**ONE - GIRDER - G3A (DEV)**

SURFACE PREP. & PAINT: -STEEL WITHIN 10'-0" ENDS OF GIRDERS SHALL BE PAINTED (SEE GNI) -ALL OTHER STEEL SHALL BE BLAST CLEANED AND LEFT UNPAINTED.	
DESCRIPTION: GIRDER - G3A	DRAWN BY: ATD DATE: 08/15
JOB: VT RTE 9 OVER THE DEERFIELD RIVER	CHKD BY: DO DATE: 08/16
BRIDGE NO. 25	APPROV BY: SUPERVISOR W. J. GATTI
SEARSBURG, VERMONT	
CONTRACTOR: J.A. McDONALD	
PROJ. NO. PROJ. NHF 010-1(18)	Q.A.
CUSTOMER: VERMONT AGENCY OF TRANSPORTATION	
<b>CASCO BAY STEEL STRUCTURES, INC.</b>	JOB NO. 165 DRG. NO. 3
75 SPRING HILL ROAD SACO, MAINE 04072	REV. Δ
PHONE (207) 282-7360 FAX. (207) 282-1179

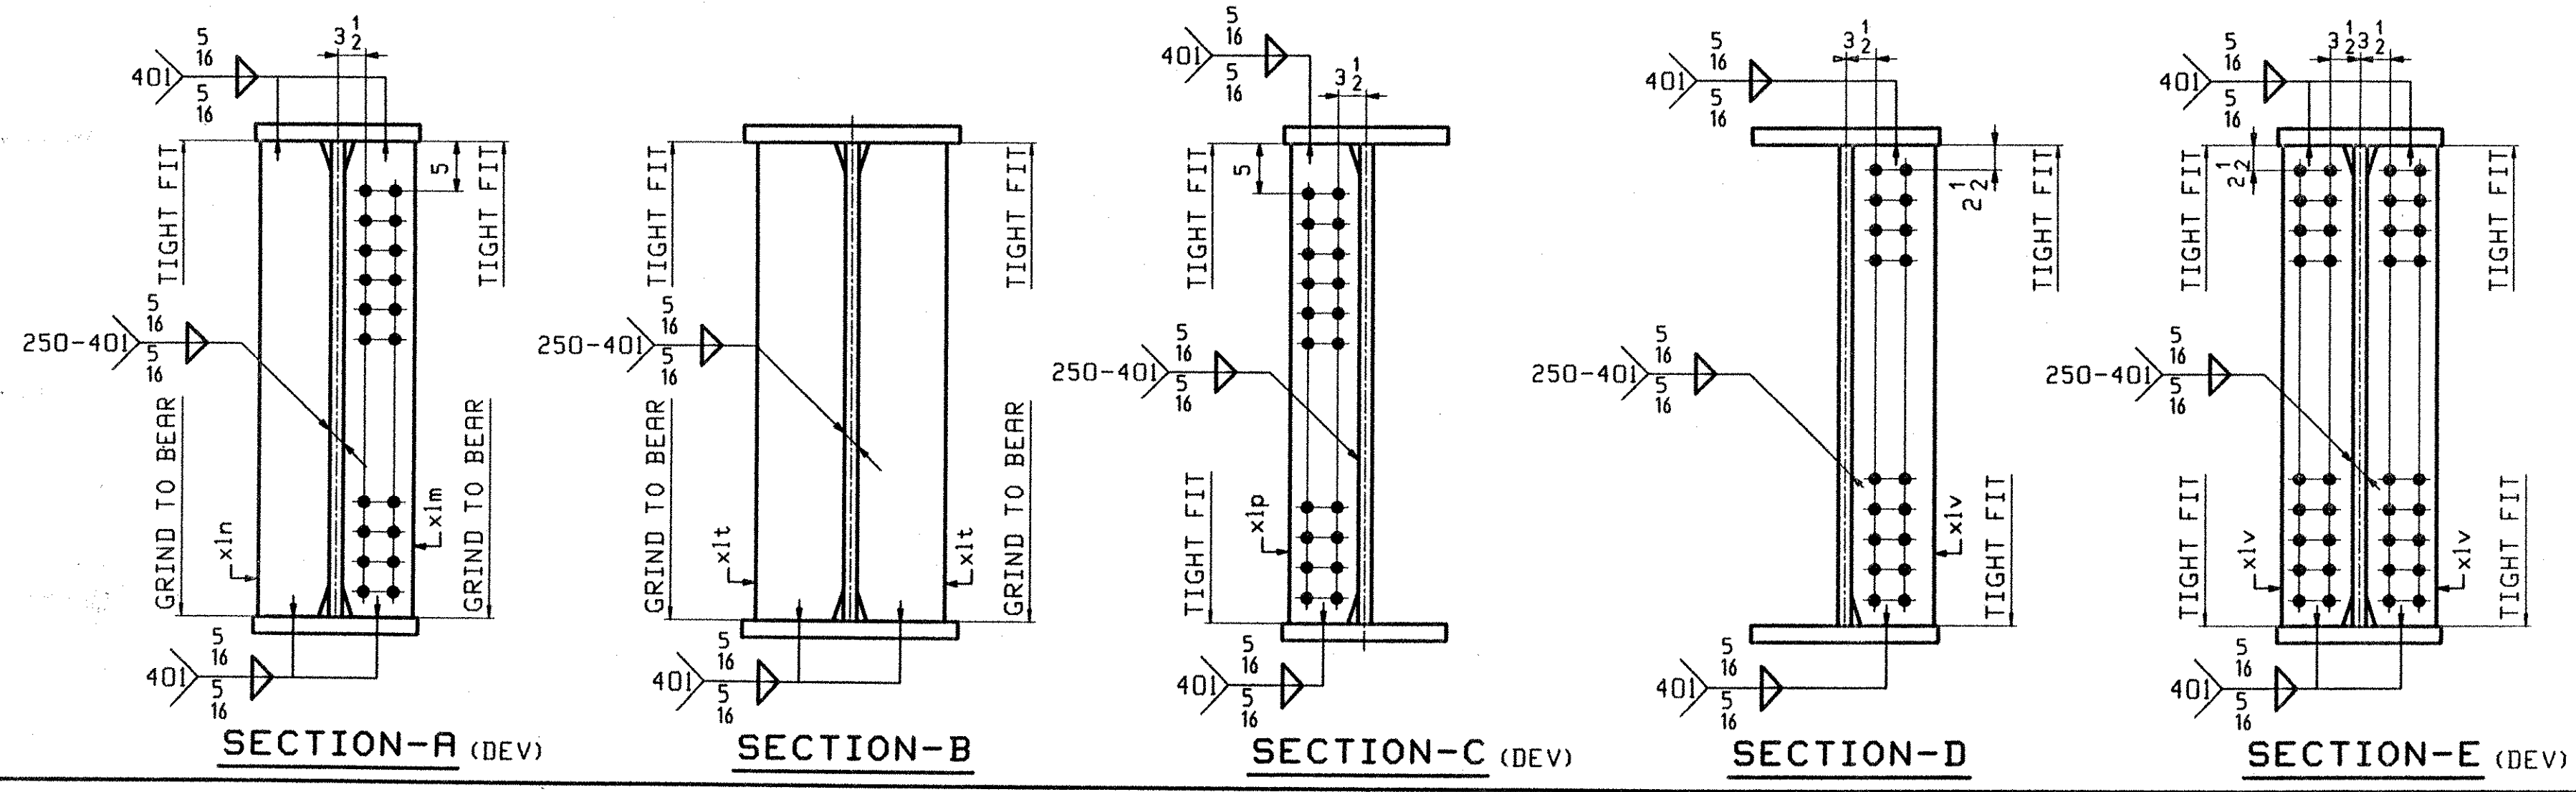
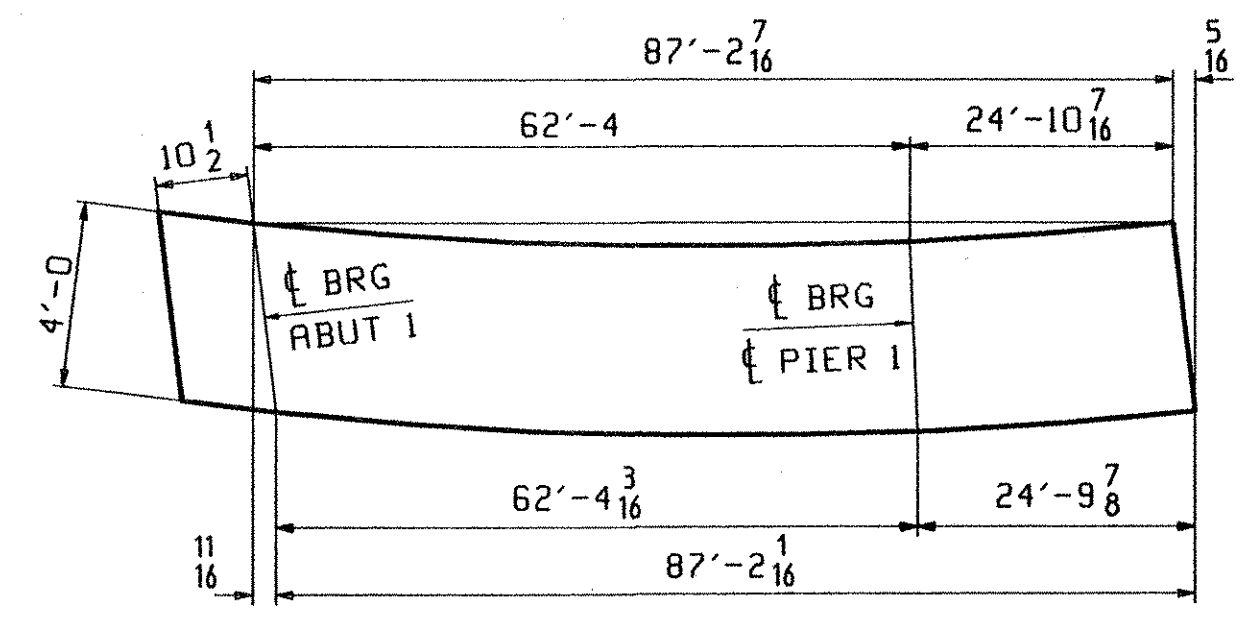
RECEIVED  
 OK'D BY DV OK'D BY \_\_\_\_\_  
 AUG 26 2002  
 RESUBMIT \_\_\_\_\_ APPROVED \_\_\_\_\_  
 BY RW DATE 9-17-02
